Access Compliance Report

Public Rights-of-Way

Intersection ID: 28115	Main Street: DARBY_CHASE_DR	Cross Street: PROVIDENCE_GREEN_CT	Location: NW
ADA ID: F2D5BC0B49B1	Ramp Type: BlendTrans1	Initial Pass/Fail: Fail	Overall Compliance: No
		Severity Score: 35

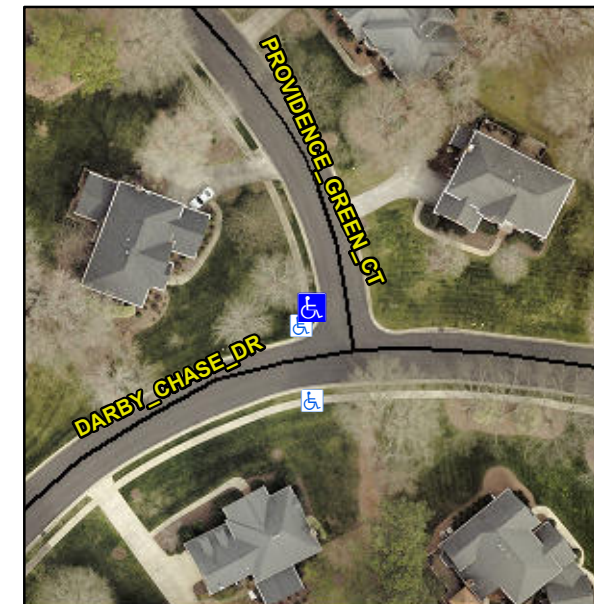
Not Found, R304.5.1

Compliance	Description	Data	Compliance	Description	Data
N/A	Ramp Length (in)	46.0	Yes	BlendTrans Slope (%)	3.7
No	Ramp Width (in)	29.0	Yes	BlendTrans XSlope (%)	0.4
N/A	Flare Type LT	N/A	N/A	Flare Type RT	N/A
N/A	Flare Slope LT (%)	N/A	N/A	Flare Slope RT (%)	N/A
N/A	Flare Traversable LT?	N/A	N/A	Flare Traversable RT?	N/A
N/A	Landing Length (in)	N/A	N/A	DWS Provided?	N/A
N/A	Landing Width (in)	N/A	N/A	DWS Contrast?	N/A
N/A	Landing Slope (%)	N/A	N/A	DWS Length (in)	N/A
N/A	Landing X Slope (%)	N/A	N/A	DWS Full Width?	N/A
N/A	Landing Curb? (Y/N)	N/A	N/A	DWS Offset (in)	N/A
N/A	Shared Landing?	N/A			
N/A	Gutter Ponding?	N/A	N/A	Gutter Slope (%)	N/A
N/A	Gutter Lip Ht (in)	N/A	N/A	Gutter X Slope (%)	N/A
N/A	Painted X Walk1?	No	N/A	Painted X Walk2?	N/A
	X Walk 1 Direction	To E		X Walk 2 Direction	N/A
	X Walk 1 Width (in)	N/A		X Walk 2 Width (in)	N/A
	X Walk 1 Slope (%)	4.5		X Walk 2 Slope (%)	N/A
	X Walk 1 X Slope (%)	0.6		X Walk 2 X Slope (%)	N/A

N/A	Ramp inside XWalk1?	N/A	N/A	Ramp inside XWalk2?	N/A
	Road Slope (%)	0.6		Clear Space?	N/A
	Road X Slope (%)	4.5	N/A	Clear Space to XWalk (in)	N/A
N/A	Any Obstructions?	N/A	N/A	Storm Grate/Utility Hazard?	N/A
	Obstruction Type			Storm Grate/Utility Type	
		N/A			N/A
			Yes	Surface Condition? (G/P)	Good
			No	Curb Slope (%)	18.5

Remove & Replace Curb Ramp With Two New Directional Ramps or Equivalent.
